REVISIONS				
PROJECT	Maydencroft Loft			
ADDRESS	Maydencroft Manor, Gosmore, Hertfordshire, SG4 7QA			
B L A K E A R C H I T E C T S	Blake Architects Limited			
	1 Coves Barn, Winstone Gloucestershire. GL7 7JZ [t] 01285 841407 [e] mail@blakearchitects.co.uk www.blakearchitects.co.uk			
TITLE	Proposed West Elevation			
DRAWING NUMBER	25.11.03.28			
STATUS	PLANNING			
DRAWN	CHECKED	DATE	SCALE	REVISION
GY	JN	06.03.26	1:100 @ A3	-

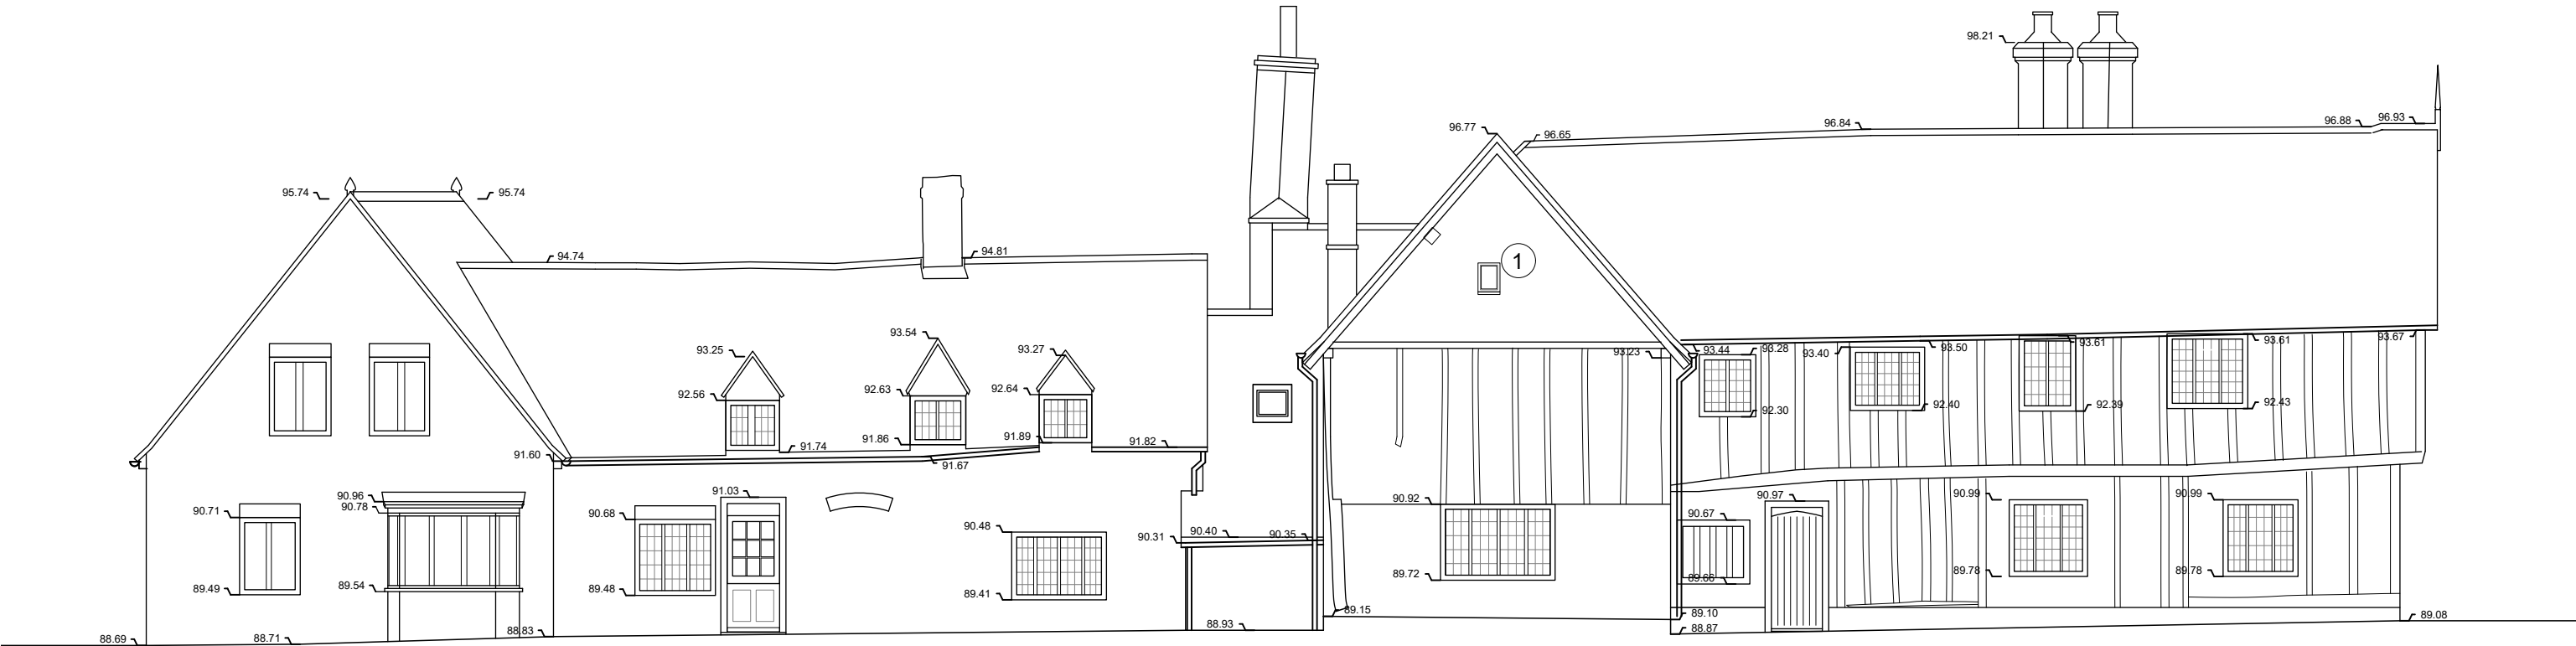
1 Re-insertion of hatch as fixed glazed light.
